4621105 POST-TENSIONING
COMMENTS FROM INDUSTRY REVIEW

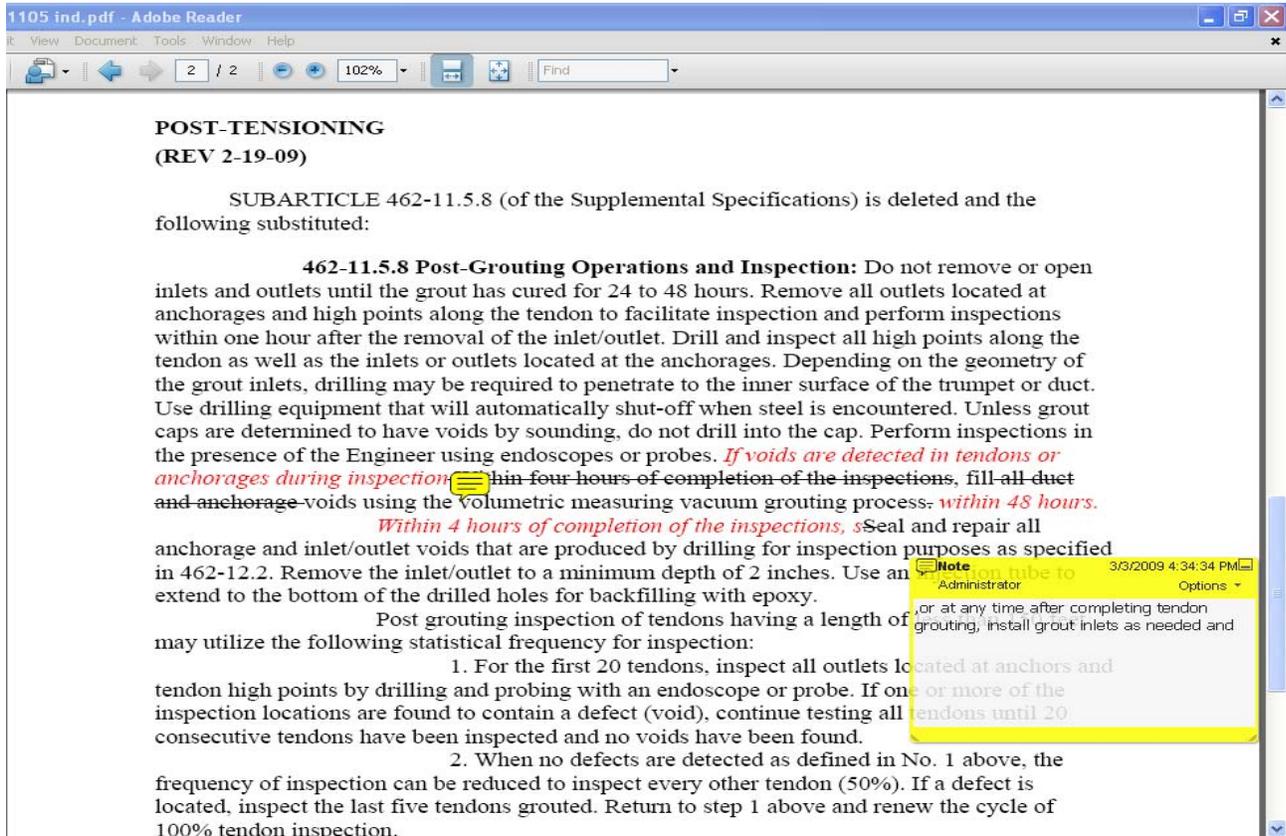
Consider the following in place of what has been proposed:

If voids are detected in tendon ducts or anchorage sockets during inspection...

Response: Agree with tendon ducts but do not agree with anchorage sockets. Changes have been made to the above spec.
